**CITY OF WEST LINN**  
**PRE-APPLICATION CONFERENCE MEETING**  
**SUMMARY NOTES**  
**September 15, 2022**

**SUBJECT:** Flood Management Area Development Permit and Willamette River Protection Area Permit at 3801 Calaroga Dr.

**FILE:** PA-22-26

Project	21-05-05	Sheet	G-2
Date	8/28/22		
Scale	3/32" = 1'

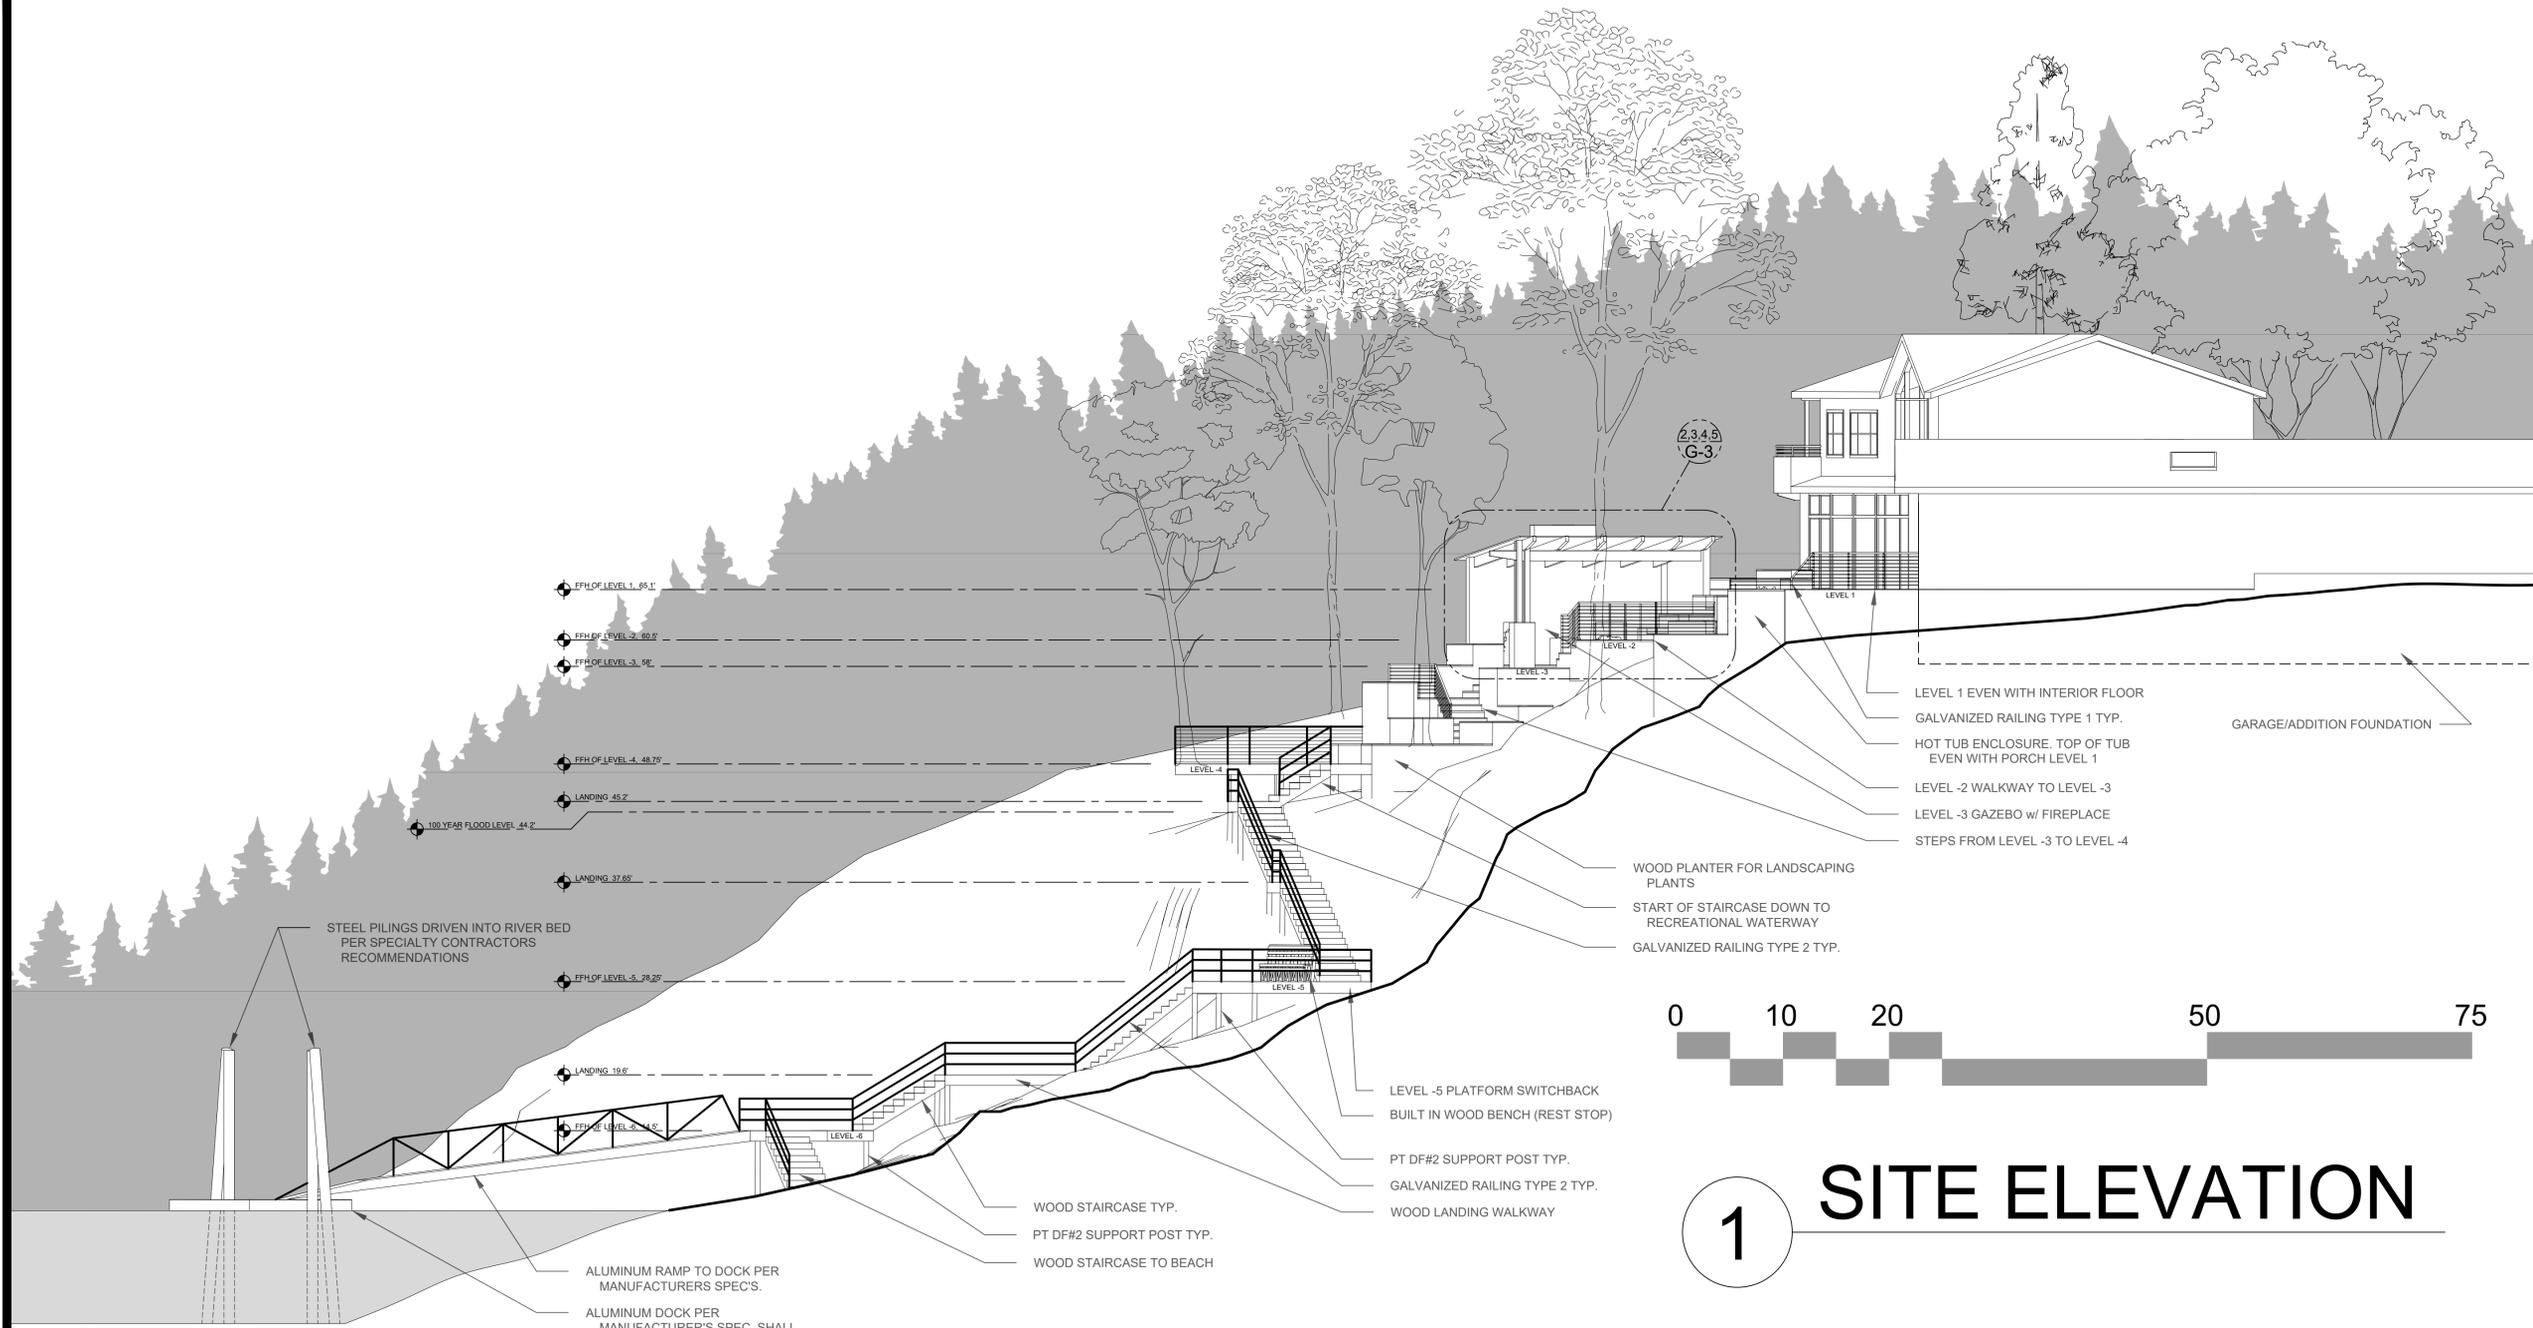
- Redesign of the easternmost wood platform and walkway should be reconsidered as (1) it is located on top of a sewer manhole, and (2) it appears to be located nearly adjacent to the side property line and a 7.5 foot sideyard setback is required. If the setback cannot be met, a variance may be required per CDC 75.
- A Flood Hazard Development Permit shall be required for the project subject to submittal requirements in CDC 27.060(C) and standards in CDC 27.070-090.
- A Willamette Greenway Permit will be required, subject to the following:
  - Submittal requirements are found in CDC 28.090 and CDC 28.120 - 160
  - Approval Criteria are found in CDC 28.110

*Engineering's only concern is the proposed wood platform/walkway is shown to be built over the top of a sanitary sewer manhole cover near the NE property line. Please let the Applicant know that they will need to redesign that section of the platform so that the manhole cover is not covered by any permanent structures.*
